Project Code & Schematics Subject:	M930 Main Board	PCB P/N:	(IRIS) (Hannstar)
------------------------------------	-----------------	----------	----------------------

FOXCONN		HON HAI Precision Ind. Co., Ltd.	
		CCPBG - R&D Division	
Title	Index Page		
Size	Document Number		
Custom	M930 (MBX-215)		Rev SB
Date:	Wednesday, August 12, 2009	Sheet 1	of 96

M930 (IRX-5100) Calpella Platform+ nVIDIA N11P/M Discrete Graphic

DDR SYSTEM MEMORY A

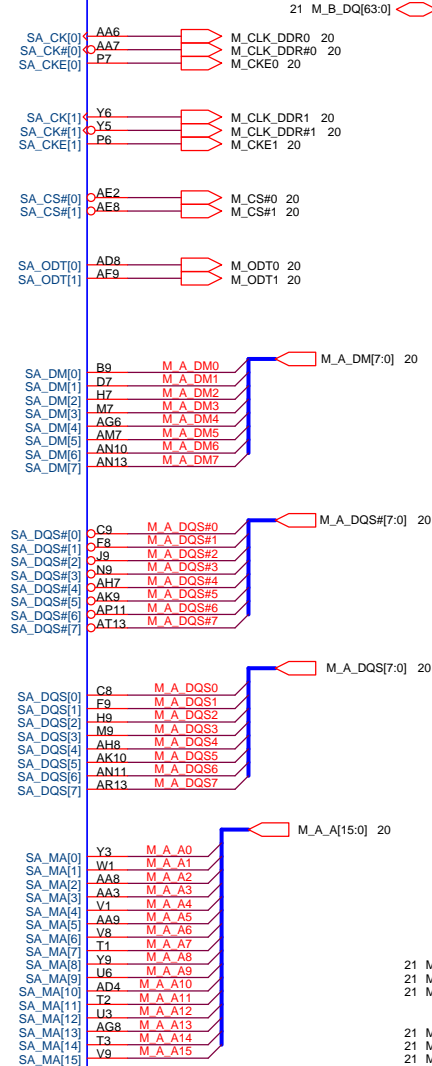
7/13 [DVT] Change to 988A socket.

DDR SYSTEM MEMORY - B

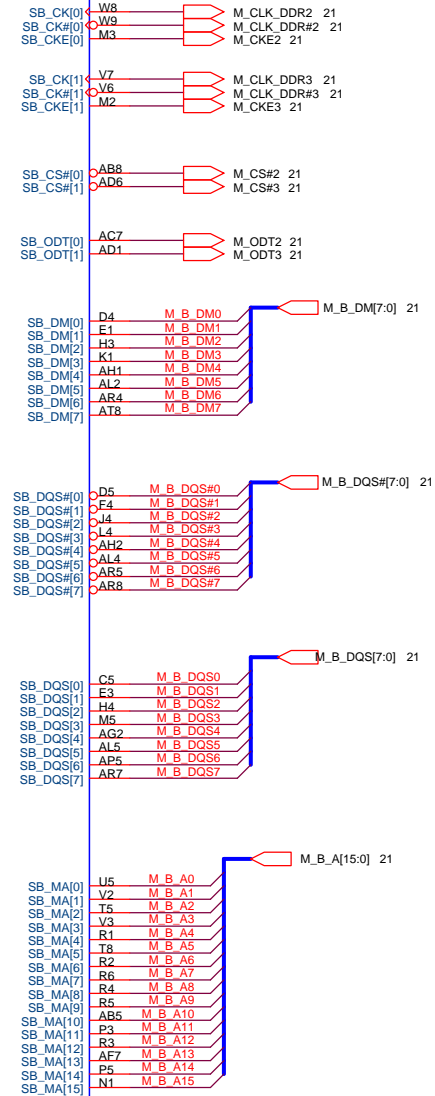
7/13 [DVT] Change to 988A socket.

TV_FPC CONN_50P
FOX_GB12501-10510-7H

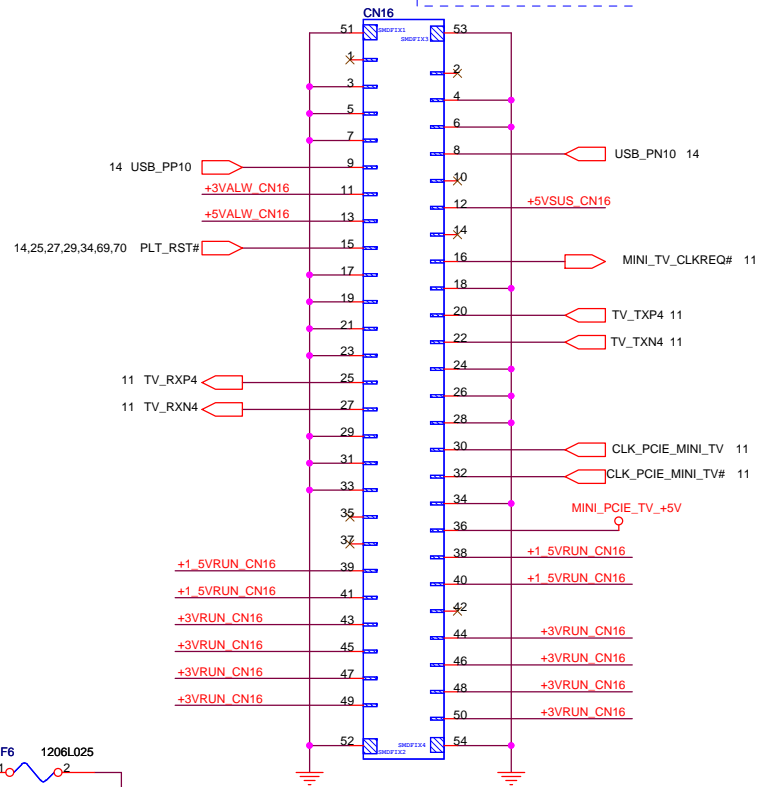
7/13 [DVT] CN16 change to GB12501-10510-7H

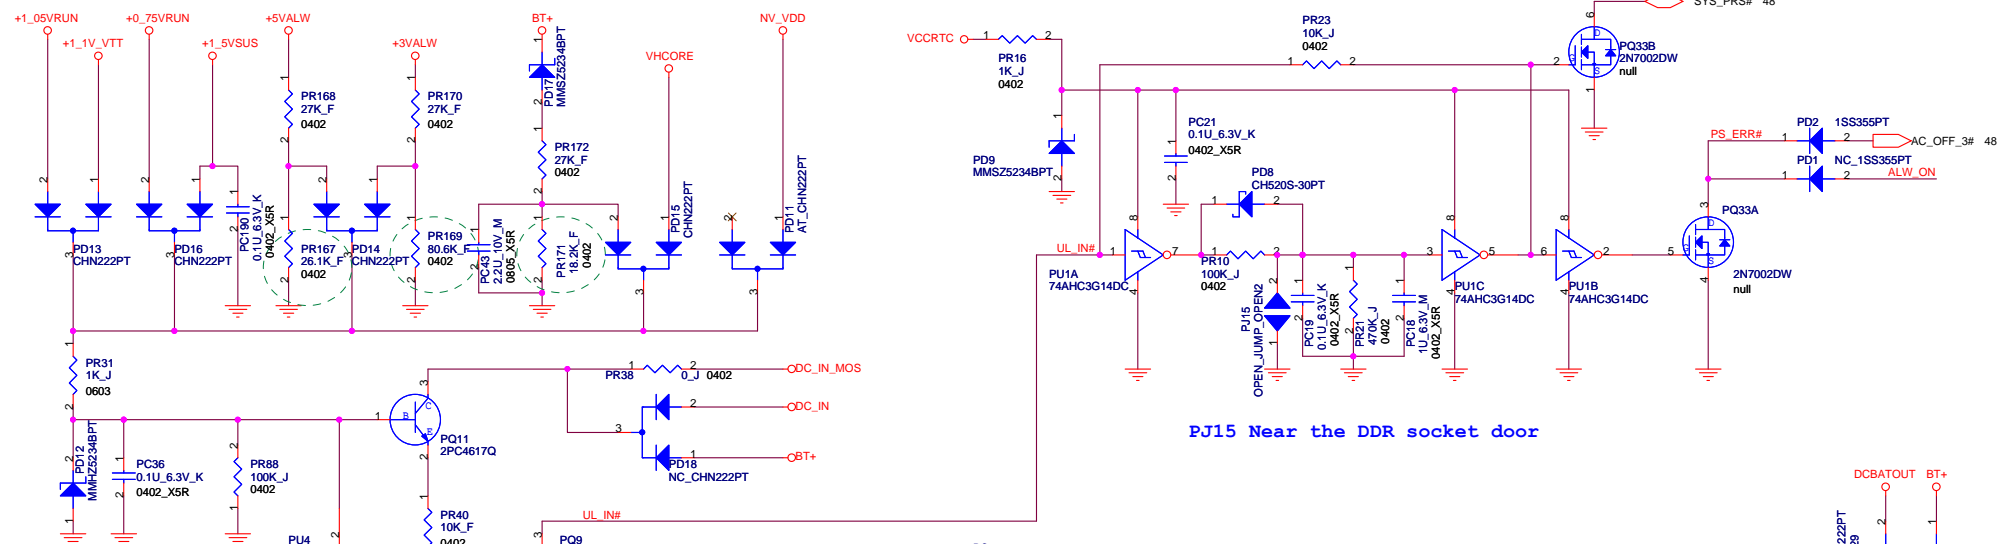
7/17 [DVT] PR167 change to 26.1Kohm, PR169 change to 80.6Kohm ,PR171 change to 18.2Kohm for OVP Adjust.

PWRLIMIT Protect

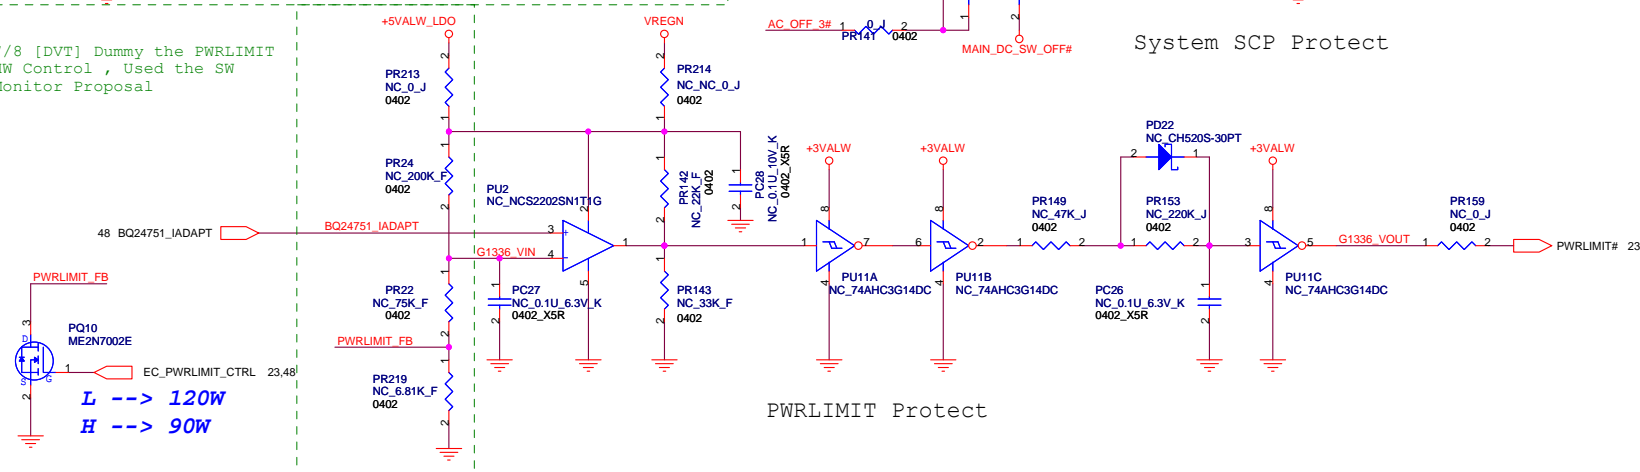
7/8 [DVT] Dummy the PWRLIMIT
HW Control , Used the SW
Monitor Proposal

INV CONNECTOR

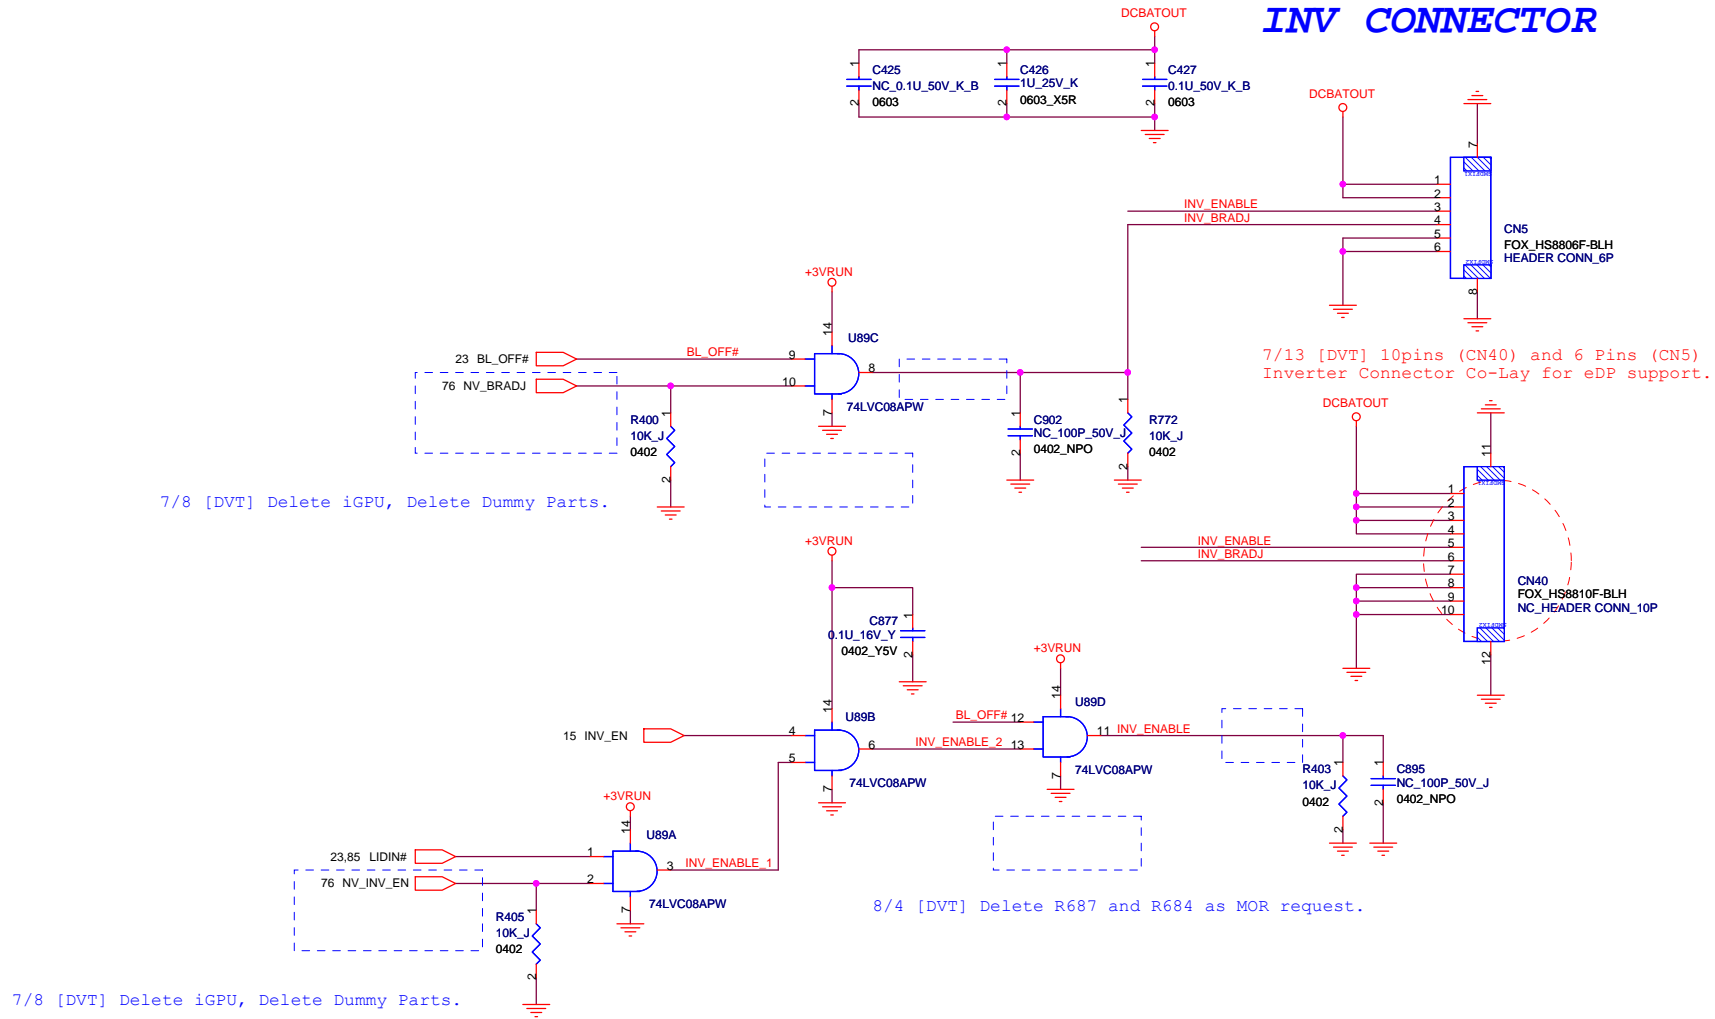
7/8 [DVT] Delete iGPU, Delete Dummy Parts.

7/15 [DVT] Delete U46 to fix the DISPLAY OFF function issue.

7/15 [DVT] Change R136 from 100Kohm to 10Kohm.

INTERNAL SPEAKER

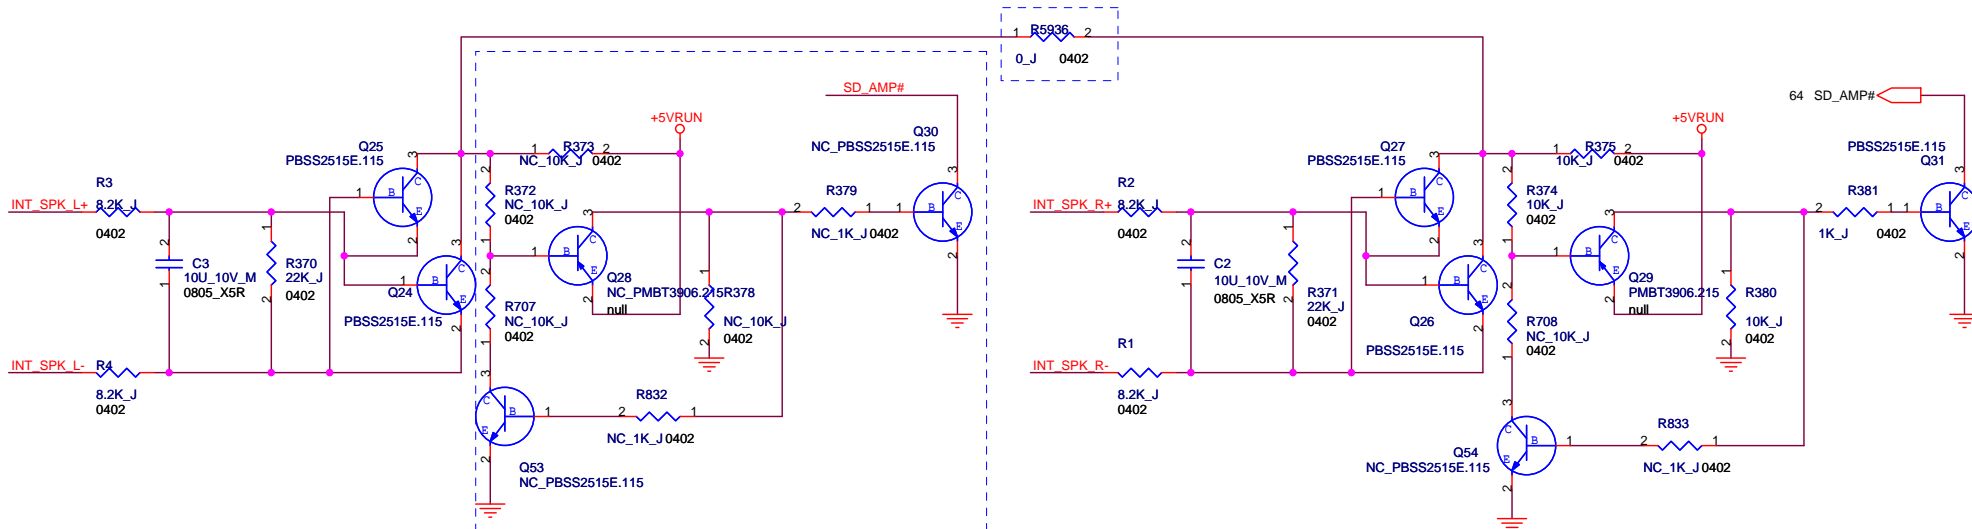
8/10 [DVT] Reserve the L-ch parts and add R5936 for C/D as MOR request.

Logical Strap bit Mapping

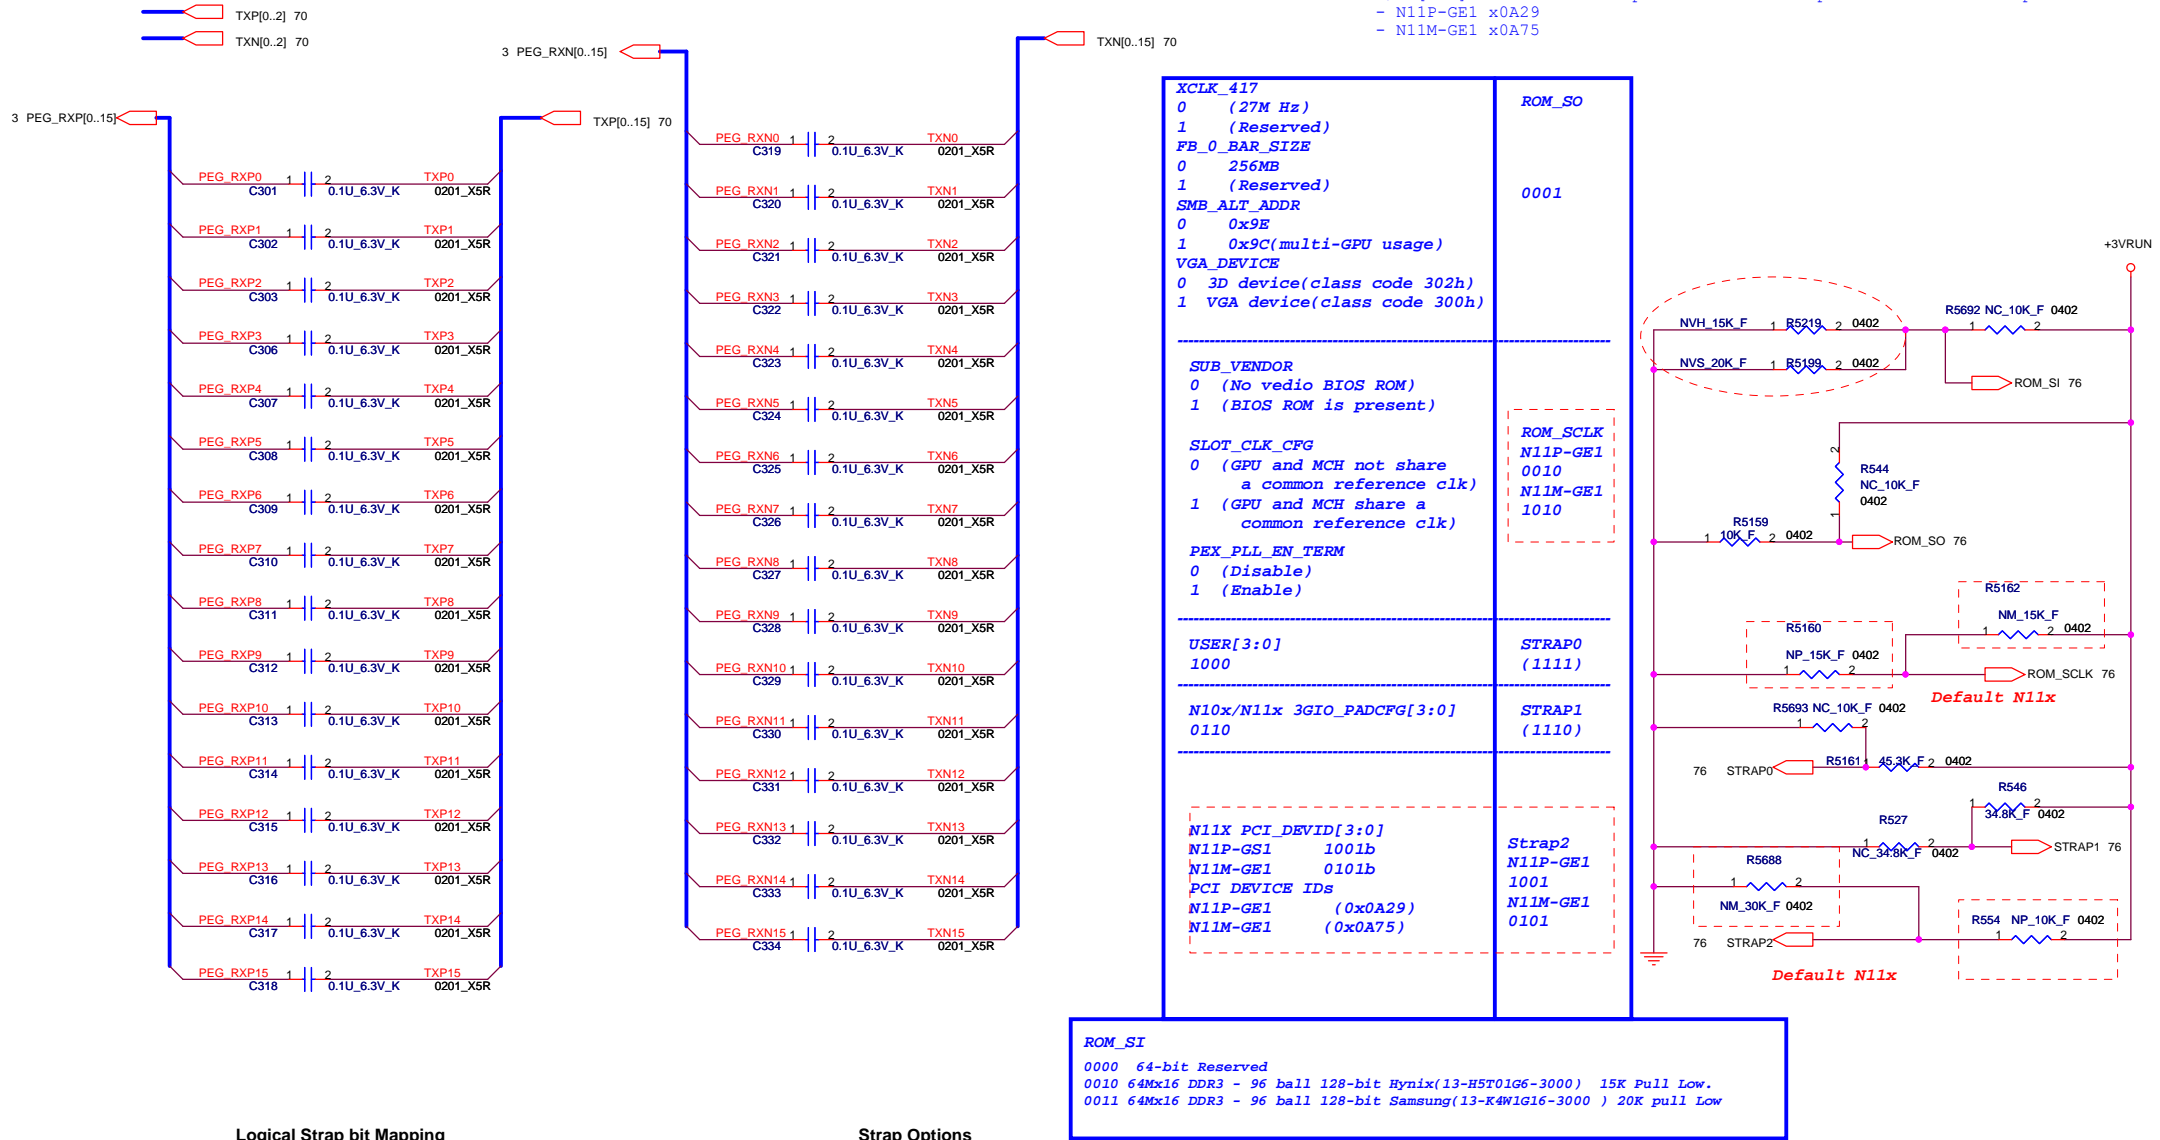
8/3 [DVT] Revise the Strap Pin value as FAEprovided for DVT Sample.
- N11P-GE1 x0A29
- N11M-GE1 x0A75
